- 6. Tutl'uh Subdivision Carmody Addition; KPB File 2022-068
McLane Consulting Group / Gwartney
Location: A Street & Hope Highway
Hope Area / Hope-Sunrise APC**

ITEM 6 - TUTL'UH SUBDIVISION CARMODY ADDITION

KPB File No.	2022-068
Plat Committee Meeting:	June 13, 2022
Applicant / Owner:	Frank Gwartney of Anchorage, AK
Surveyor:	James Hall / McLane Consulting
General Location:	Hope Highway, A Street, Hope / Hope/Sunrise APC

STAFF REPORT

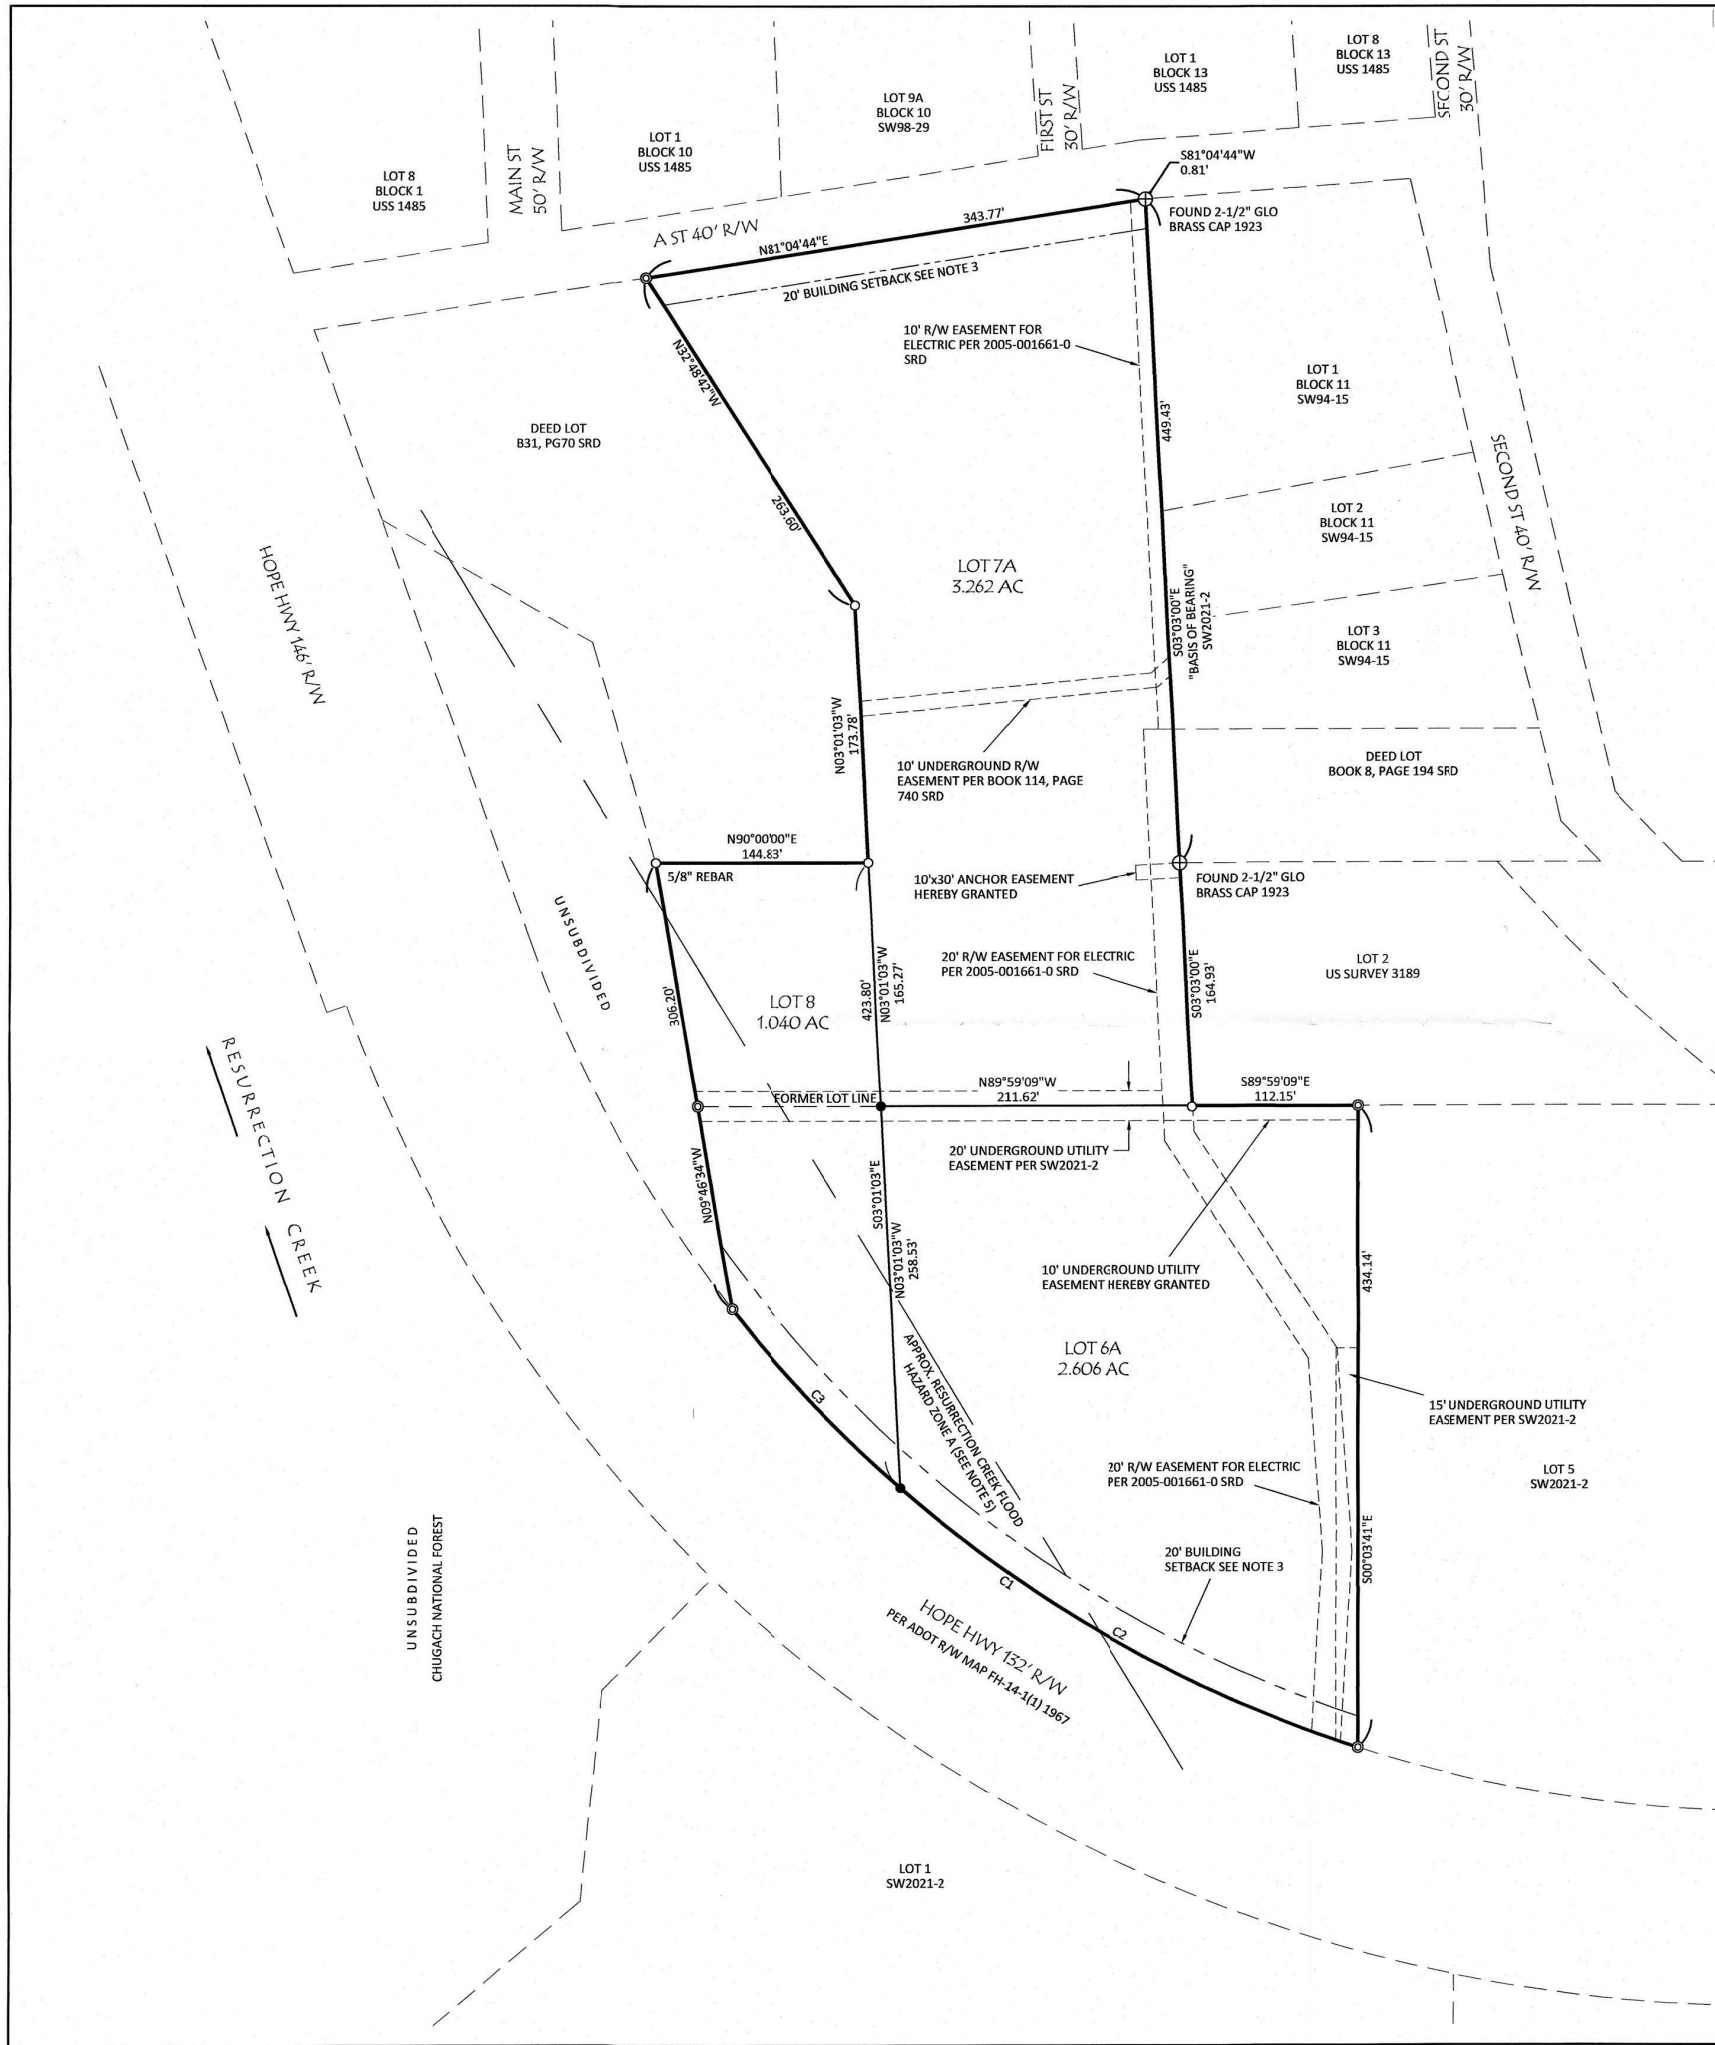
There appears to be multiple improvements on the property. Using KPB GIS Imagery, it cannot be determined the status and if any are permanent. There is an existing structure that will be on proposed Lot 6A that appears to be accessed through proposed Lot 7A. It would be recommended if this access is to continue in the future and either property has an ownership change, a driveway or private access easement document be recorded. It does appear that there may be an existing driveway from the Hope Highway that would provide additional access to the structure. **Staff recommends** the surveyor verify that there will be no encroachments created by this plat and add the borough encroachment note.

The parent plat was subject to an anadromous habitat protection district. This preliminary plat is not and plat note 6 can be removed.

Utility Easements Numerous easements have been granted by recorded document. They are depicted with labels noting their creation. The parent plat granted several easements which are also depicted and labeled. **Staff recommends** the label for the 10x30 anchor easement and the 10' underground utility easement within Lot 6A have the labels updated to state "per SW 2021-2".

Staff recommendation: Add the aliquot location to the description, NW1/4.

Staff recommendation: Update the depiction of the proposed plat.

Remove plat note 6.

Notes 9.1 and 9.2 state "location not defined" but the face of the plat references the notes for specific easements. Either remove "location not defined" or if the easements contained additional undefined locations change to "Additional locations other than those depicted are allowed but not defined."

- Add a plat note for any exceptions granted.
- Add a plat note for the highway reservation easement as found within the Certificate to Plat.

- The exception to KPB Code 20.30.120, street-width requirements for A Street that was granted at the November 30, 2020 Plat Committee meeting was carried over at the June 13, 2022 Plat Committee Meeting.
- Acceptance of this plat by the Kenai Peninsula Borough does not indicate acceptance of any encroachments.
